Interstoff Apparels Ltd. (9493)

29.April.2014

ACCORD
on Fire and Building Safety in Bangladesh

Identified Priority 1 Concerns

1st Priority 1 – Major concern

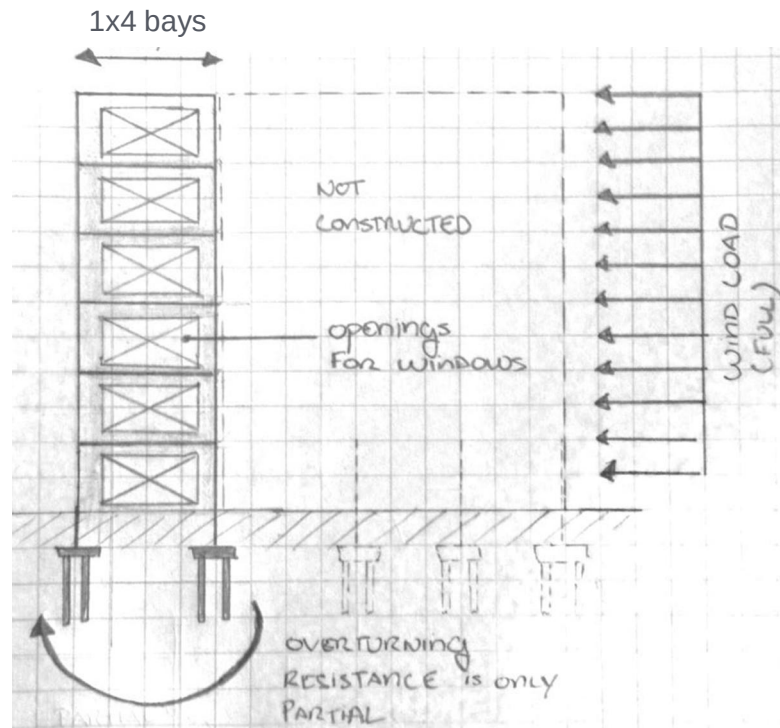
The Dining Area, Building 6. is a single storey building with a steel roof and an improvised steel mezzanine heavily loaded. No construction documents were provided for the mezzanine. The mezzanine showed advanced signs of instability and distress. The Director was advised to evacuate the area and reduce the loading.

At the closing meeting, the Director said the mezzanine would be dismantled.

Upon our departure, most of the storage was outside and being shipped off to another facility.

- Dangerous mezzanine in dining area with inadequate steel elements.
- Mezzanine to be dismantled immediately.

2nd Priority 1 Concern

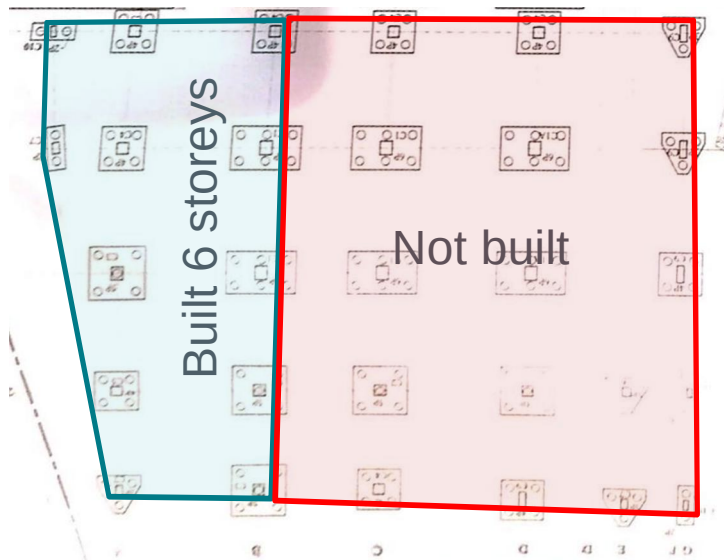
Building 2. During our visit, we found that a section of the new proposed 11 storey building (currently built to 6 and 9 storeys) had only one bay built and was currently being used. This building section has currently minimal overturning resistance and we have reasonable doubt that the piles can take the increased uplift forces due to the full wind load. This building needs to be braced or otherwise stabilised as quickly as possible.

We require that these items be investigated in a Detailed Engineering Assessment immediately.

- Commence immediate Detailed Engineering Assessment that evaluates the lateral stability of the building in its current state.
- Temporarily brace the building.
